AMENDMENT 3 TO RESAR-SP/90 PDA MODULE 9
INSTRUMENTATION & CONTROL AND ELECTRIC POWER

Instruction Sheet

REVIEW OF RESAR-SP/90
WESTINGHOUSE ADVANCED PRESSURIZED WATER REACTOR
DOCKET NO. 50-601

Figure 8.3-1
WAPWR AC Main Single Line Diagram
(Sheet 1 of 2)

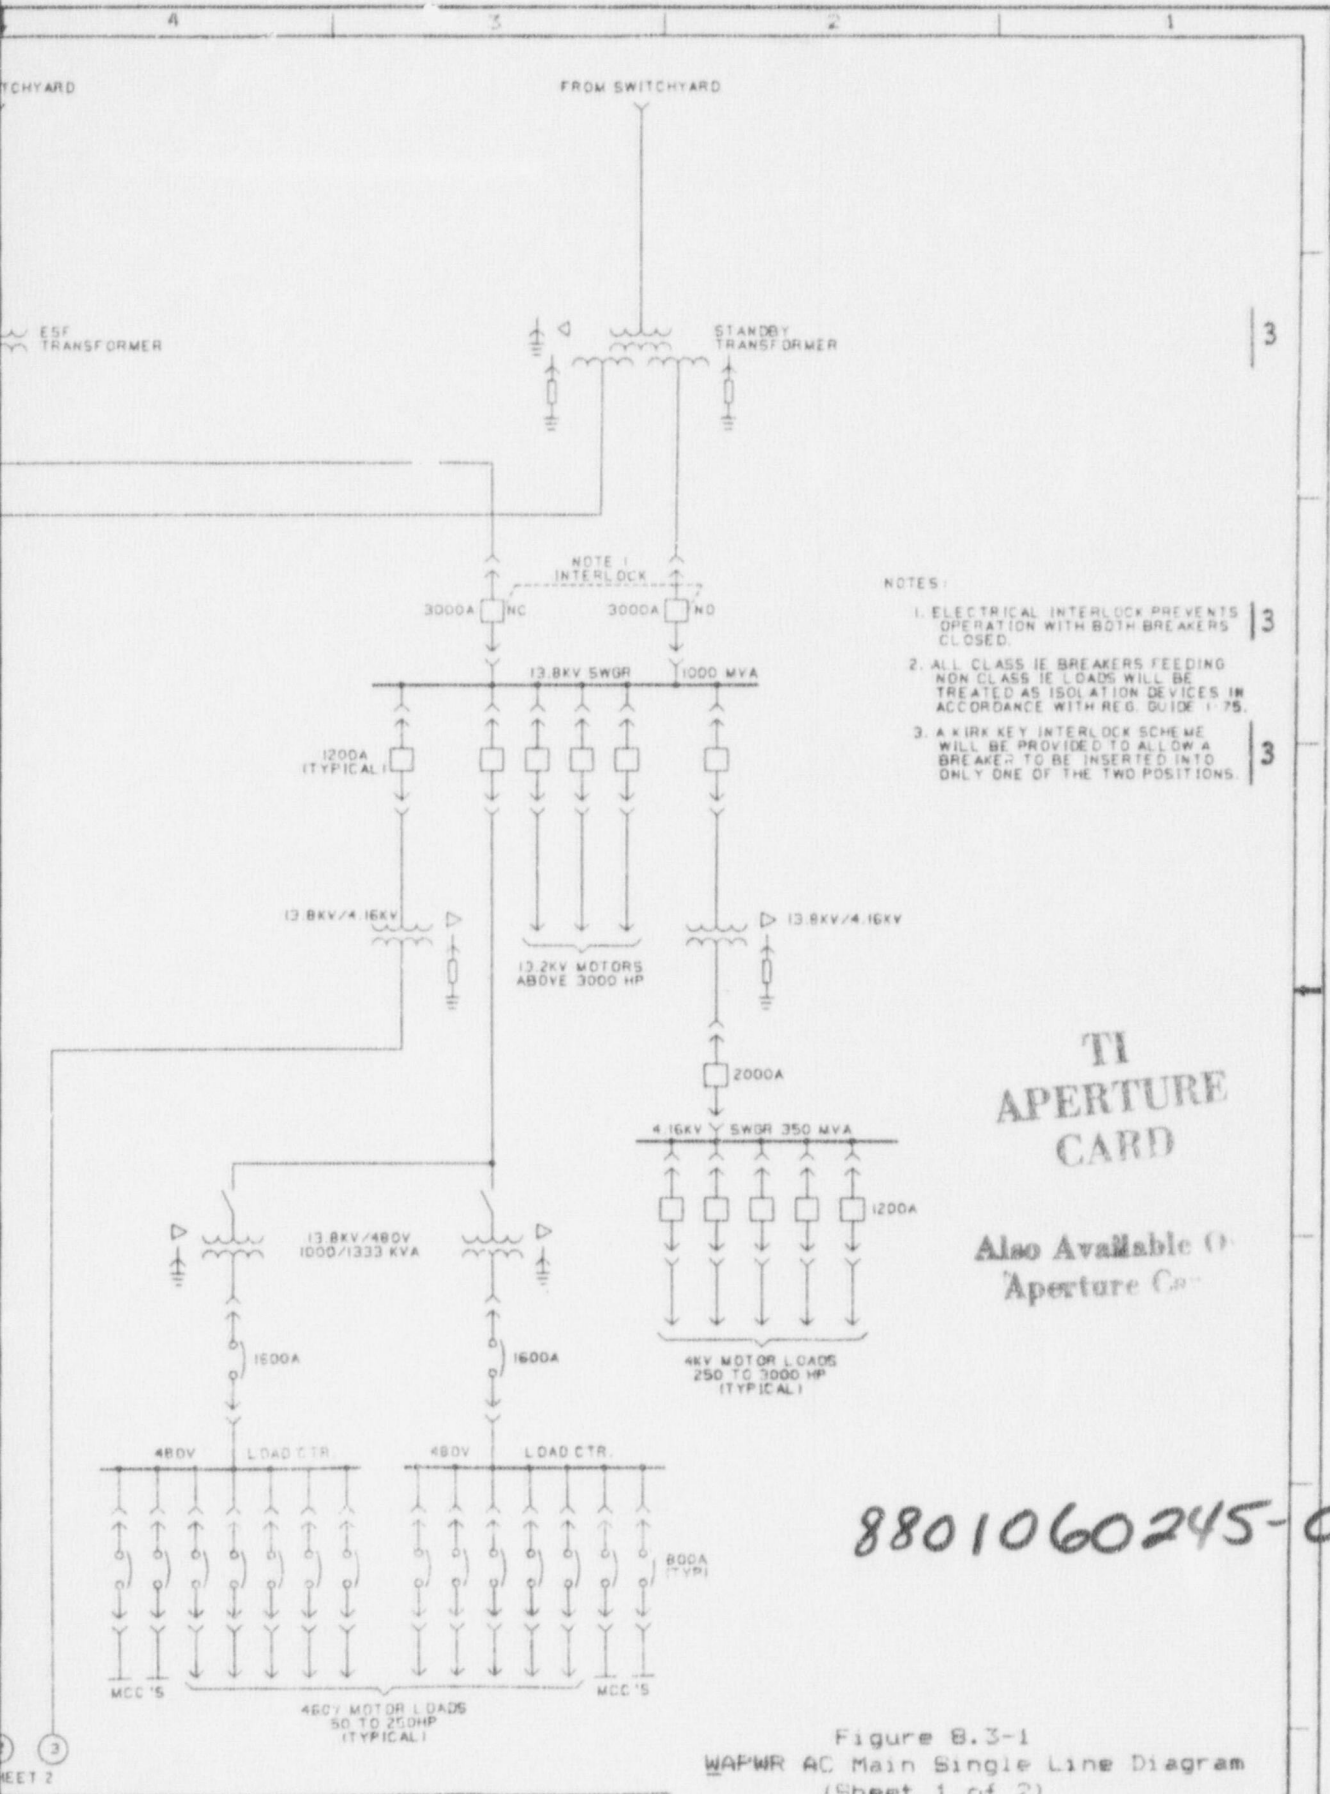
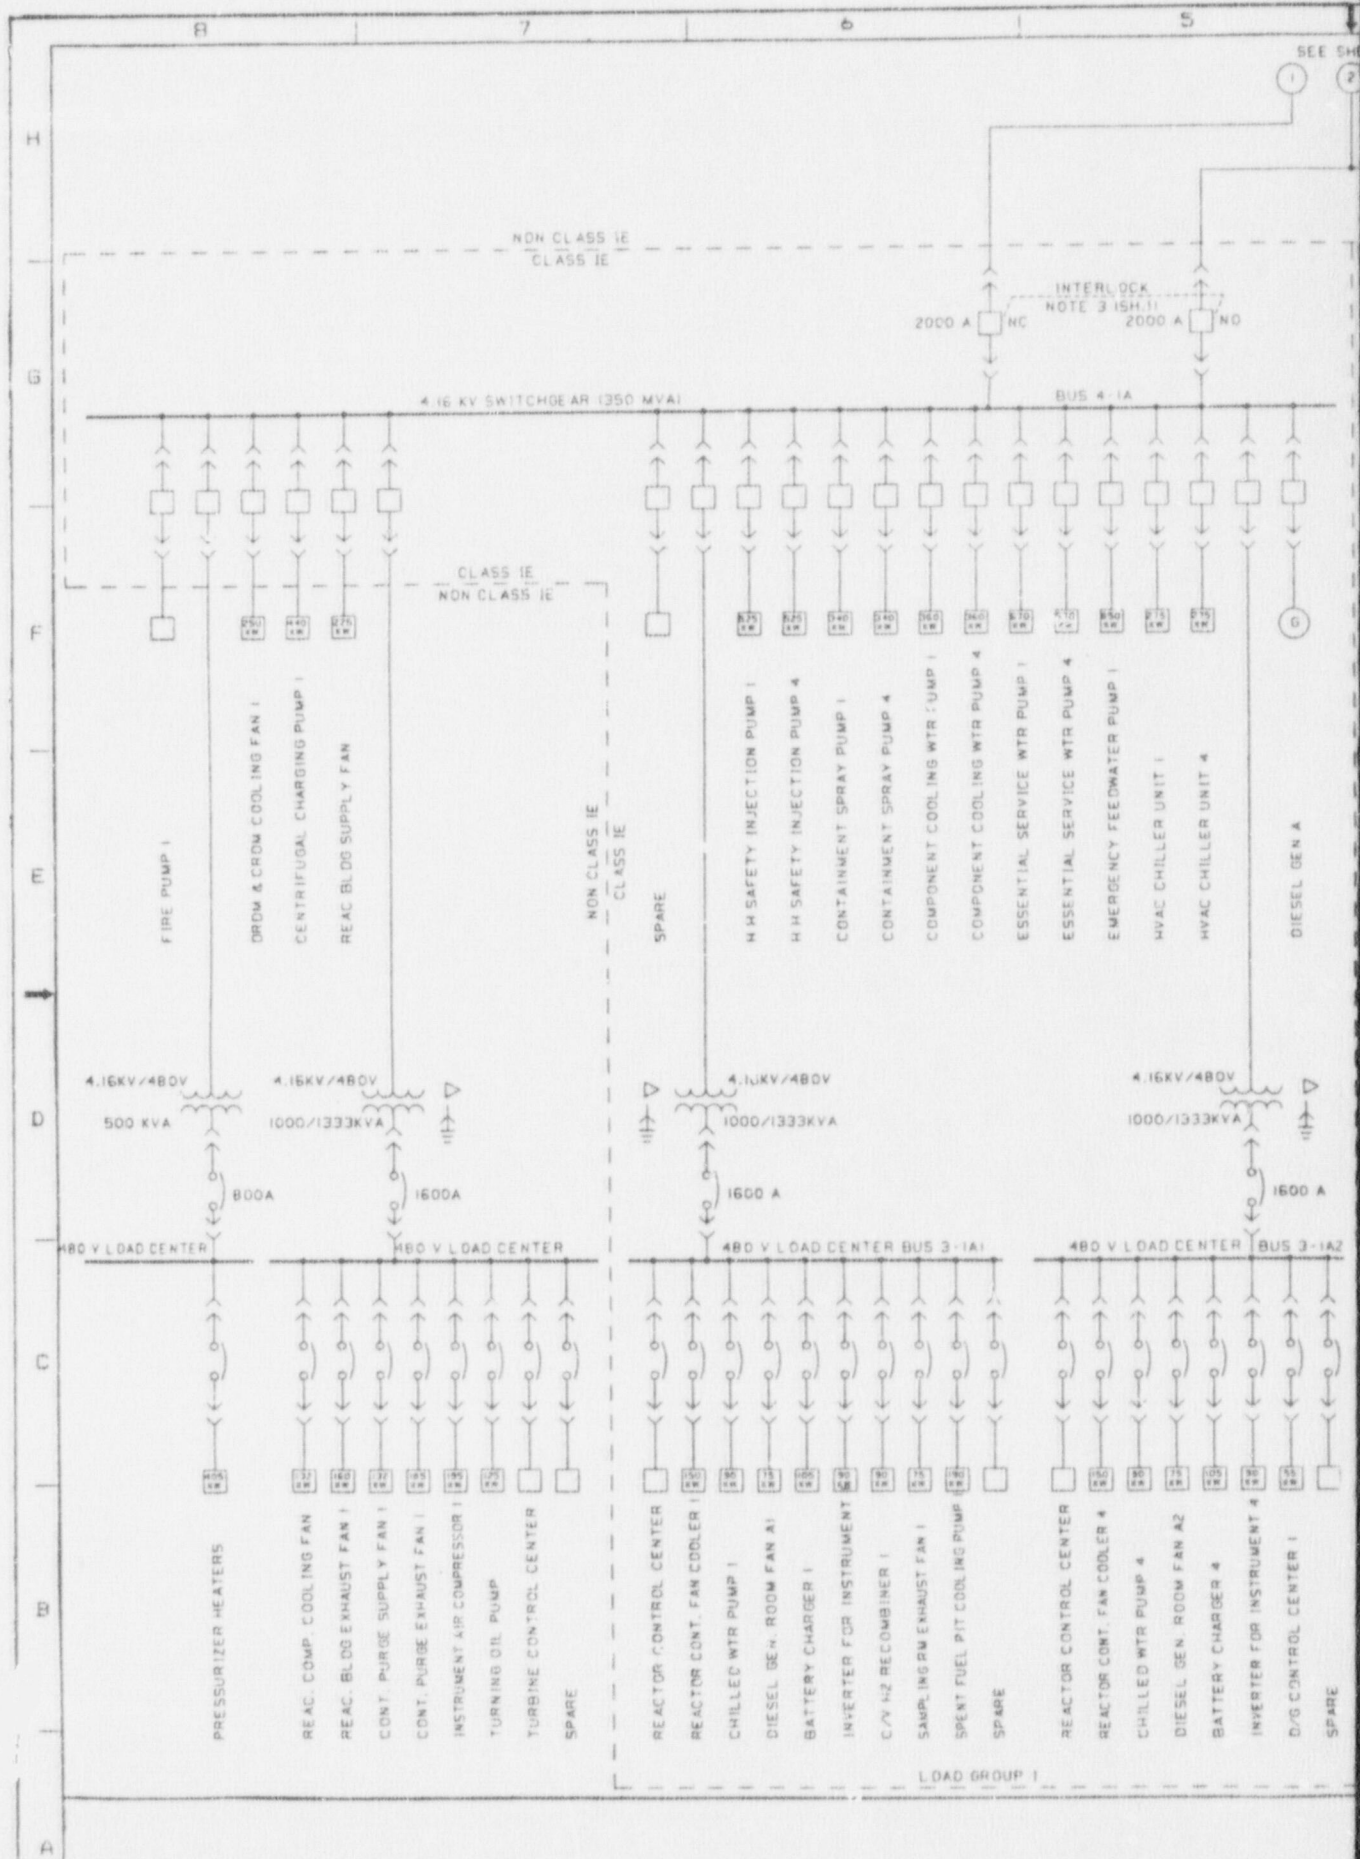
- 430.9 An area which needs to be addressed is the basis for the absence of a fast transfer (simultaneous or sequential), and/or slow transfer scheme(s) and synchronizing scheme, between the unit auxiliary transformer and the startup (or standby) transformer. In the absence of such a scheme, with a fault on either the main or unit auxiliary transformers, the reactor coolant pumps, which provide the preferred primary coolant circulation method (as opposed to natural circulation), would be tripped potentially challenging ESF systems. With the fast transfer, the other source of power will be connected to the normal bus to supply power to the reactor coolant pumps and, thus, avoid challenging the ESF systems. In the interest of design improvements for future generation plants, we suggest consideration be given to adoption of this design feature.

- 430.11 We have discovered that the information is changing as the design continues to evolve as illustrated by inconsistency in the design submitted earlier with the single line submitted in the September 10, 1987, meeting. The main generator circuit breaker shown on Figure 8.3-1 of Standard Plant Design was omitted from the single line diagram presented to the staff in September 10, 1987, meeting. Also, the standby transformer shown on Figure 8.3-1 is called startup transformer on the single line diagram submitted to the staff. It appears that your philosophy of feeding the auxiliary power systems during startup or planned shutdown has changed completely. In our opinion, this is a significant change and should be addressed in the Standard Plant Design. Explain whether during plant startup or planned shutdown you still plan to feed the station auxiliary loads via the main step up transformer through the unit auxiliary transformer with the generator breaker open as outlined in 8.3.1.1.1 or do you plan to feed the station auxiliary loads through the start up transformer with the deletion of generator breaker as shown on the single line diagram presented in the September 10, 1987, meeting.

The Standard Plant Design will provide for a fast transfer scheme of the 13.8 KV busses from the unit auxiliary transformer and the standby transformer. This transfer would be initiated only in the event of an electrical fault in the zone including the generator, generator bus, unit auxiliary transformer and main step up transformer. Synchronizing check relays will be provided to verify acceptable phase and voltage between the busses prior to initiating the transfer. The site specific evaluation will include a review of preferred and standby power sources to verify that they are compatible with the proposed scheme. Figure 8.3-1 has been revised to show only electrical (vice Kirk Key) interlocks between 13.8 KV breakers for the unit and standby transformers. Section 8.3.1.1.1 has been revised to incorporate this response.

The diagram presented at the September 10, 1987 meeting was erroneously taken from material used at a much earlier presentation. This diagram does not reflect the current Standard Plant Design. The Standard Plant Design includes a generator breaker and a standby transformer. During startup and planned shutdown, station auxiliary loads are fed via the main step up transformer through the unit auxiliary transformer. There has been no change in the Standard Plant Design in this area.

Figure 8.3-1
WAPWK AC Main Single Line Diagram
(Sheet 2 of 2)

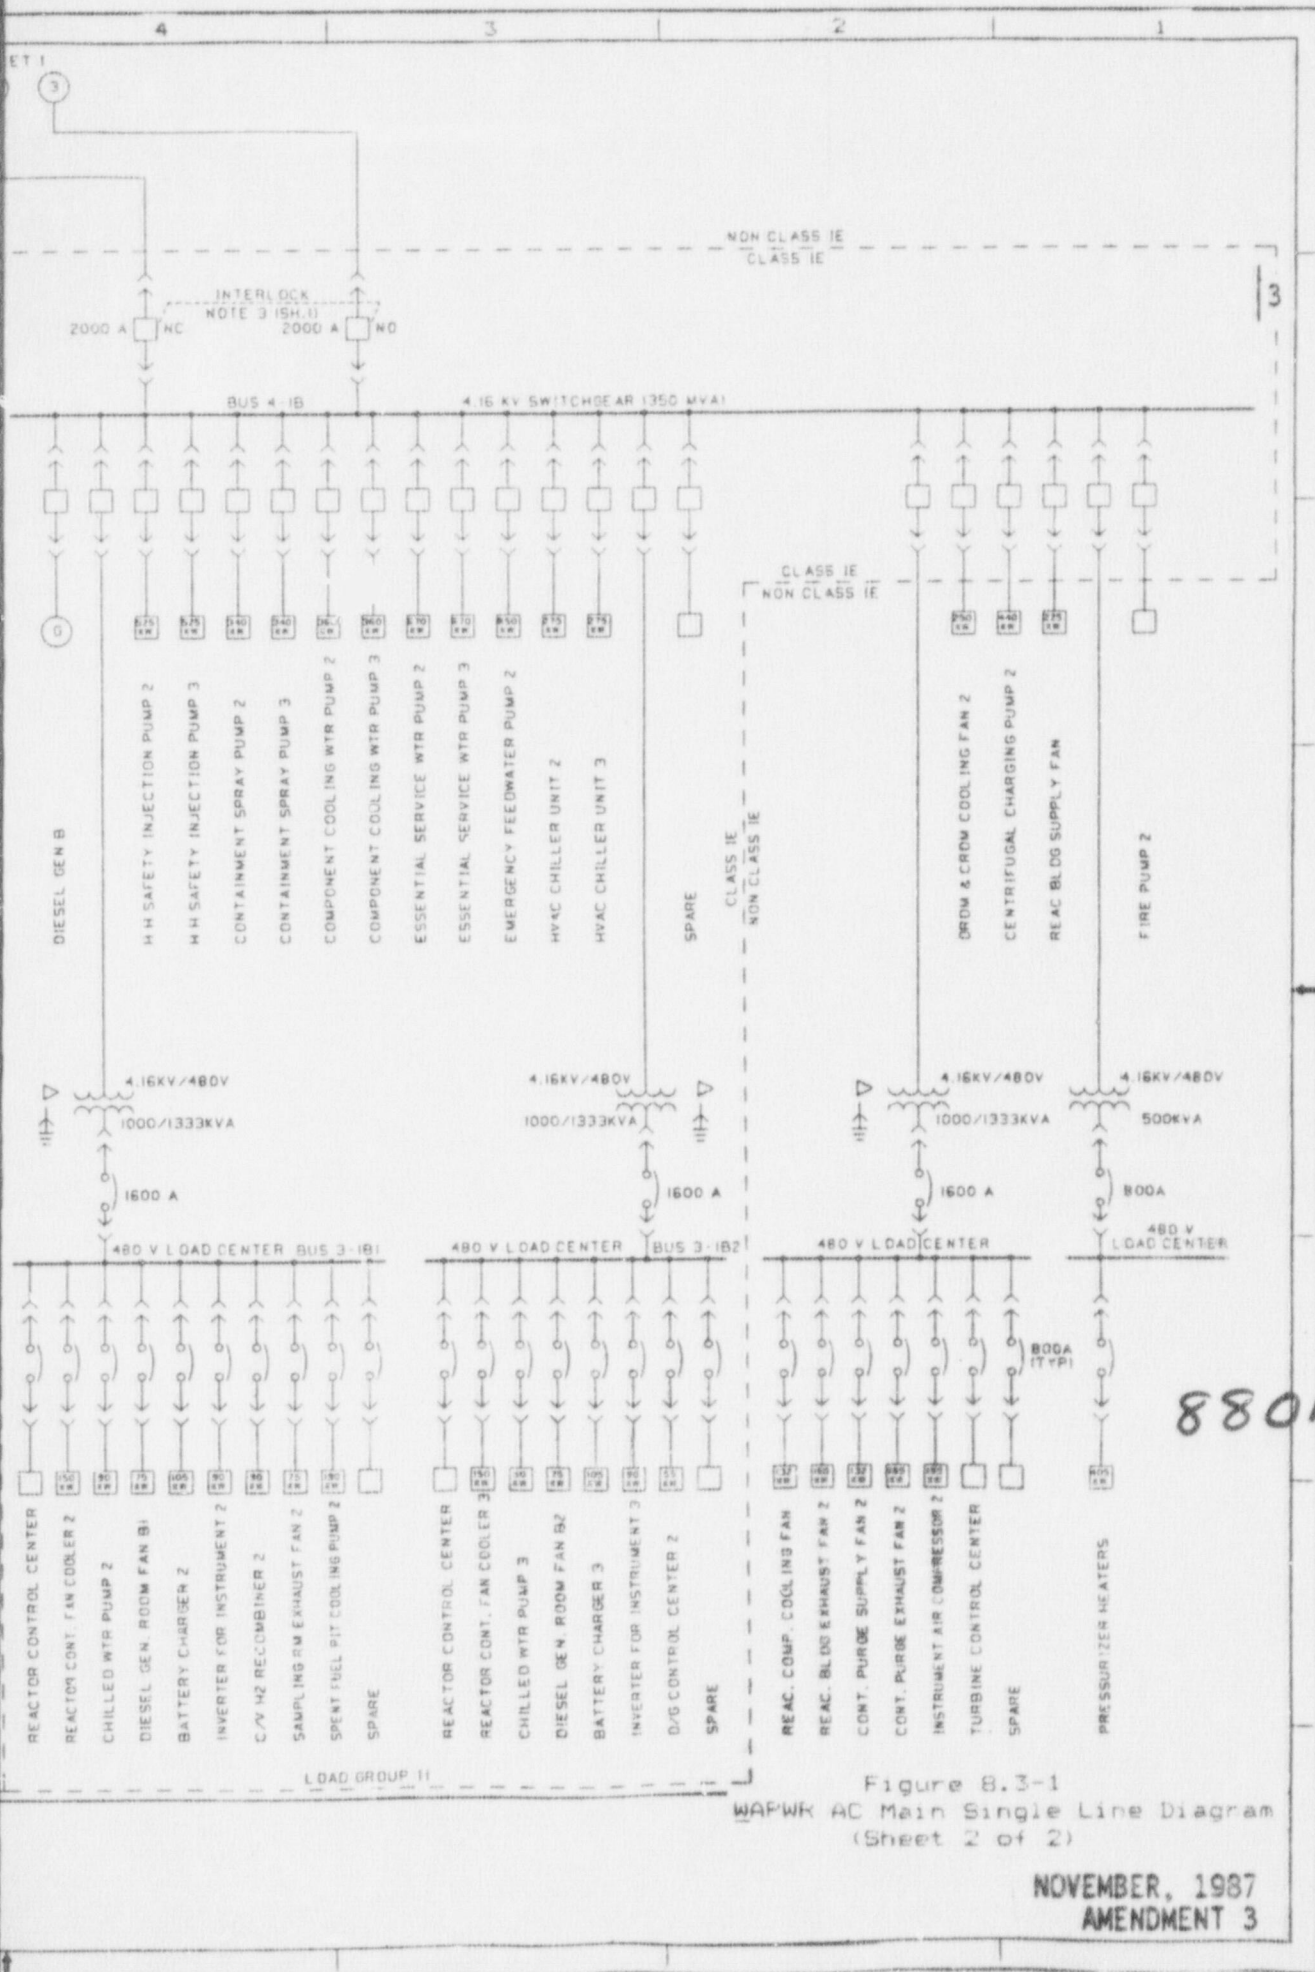
- 430.10 Another area which needs to be addressed is the absence of a secondary winding on the ESF transformer feeding the redundant Class 1E ESF buses. There should be two instead of one secondary (4.16kV) winding of the ESF transformer which feed the redundant Class 1E buses. Two secondary windings provide a degree of independence between the redundant Class 1E systems since a transient on one ESF bus would not affect the other ESF bus as much because of the impedances of the

secondary windings. This would provide a better design for future generation plants. Provide a modified design or justification for feeding the redundant Class 1E ESF buses from one secondary winding of the ESF transformer.

The ESF transformer is intended to feed only one ESF bus at a time. This protects the ESF busses from transients on a common source as well as isolating each ESF bus from a fault on the other ESF bus. Plant technical specifications will restrict operation in critical and hot standby modes when both ESF busses are being fed from the ESF transformer. Exact specification of the ESF transformer is dependent on site specific review of diversity, voltages and available fault levels of the off-site sources.
